GENERAL TOLERANCE				UNITS	mm	NAME:		ATOM [®] 深圳市爱特姆科技有限公司 SHENZHEN ATOM TECHNOLOGY CO., LTD.		
SELECT	✓					MAT'L	NAME:	USB		TITLE: USB A/F 4P DIP 90' 双层 无弹白胶 铜壳
TOL.	1	2	3	PART NO:	USB304FA-A2009307			DWG NO. ATOM-A02331		
X.XXX	±0.15	±0.05	±0.15	FINISH	APPD:	Peter		SCALE	SHEET	REV
X.XX	±0.25	±0.13	±0.25		CHKD:	Jason				
X.X	±0.30	±0.25	±0.50	Q'TY	DR:	jack				
X.	±0.38	±0.38	±1.00							
ANGLE	±4'

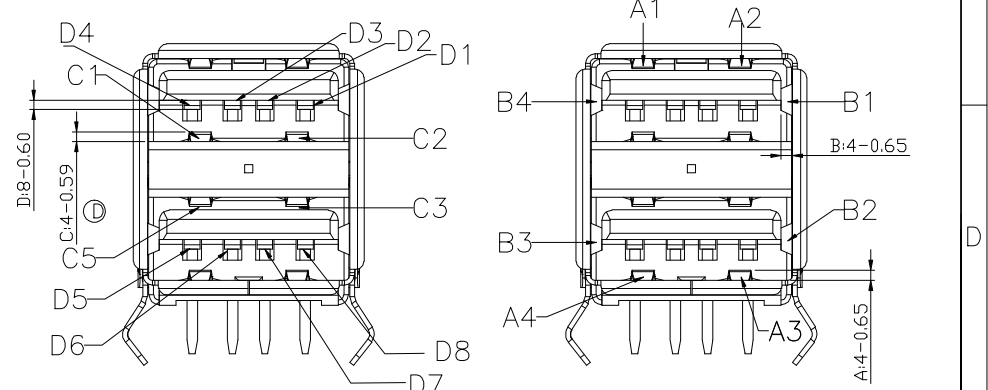
REV.	DATE	ECN NO.	MODIFICATION	APPROVER
E	2015/07/03	RD00315070301	依客户要求变更材质	JACK
F	2015/07/15	RD00315071501	依客户要求更新说明	Jason
F1	2016/02/16	RD00316021601	依客户要求变更外壳上层弹片角度, 优化插拔力	JACK
